**MEMORANDUM**

DATE: November 8, 2010  
TO: Plan Holders  
PROJECT: **Dallas Convention Center**  
**Upper Level D Meeting Room Construction**  
HKS Project No. 12418.300  
FROM: Jay Waters  
SUBJECT: Bid Period RFI Summary

**TO:** Jay Waters  
**FROM:** Ken Smith  
**RE:** Dallas Convention Center Pre-Bid Questions  
BCE Project No: 09-092  
**DATE:** November 8, 2010

### M2.05

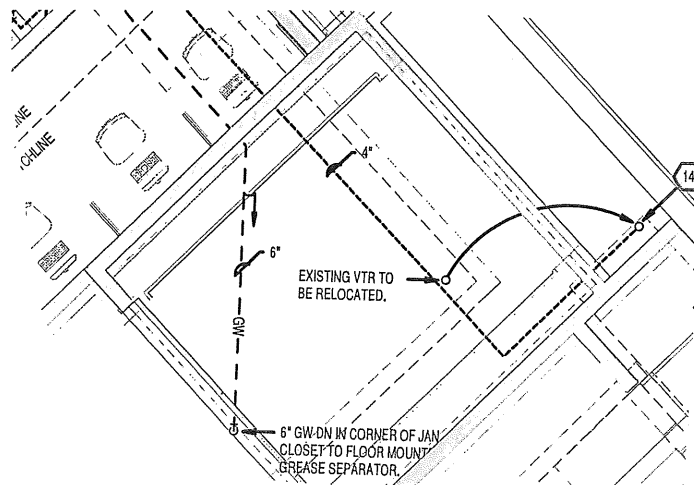
1. What is duct size off of AHU?
2. Where is hot and chilled water coming from?
3. Plan sheet notes?

1. 36" X 36" supply air duct size from AHU-R-D-1 and 24" X 36" supply air duct from AHU-R-D-2. Refer to Drawing M2.03.
2. There are existing 8" CHS/R and 4" HWS/R below roof level. Allow 50 feet of CHS/R and HWS/R to connect to existing.
3. No plan sheet notes.
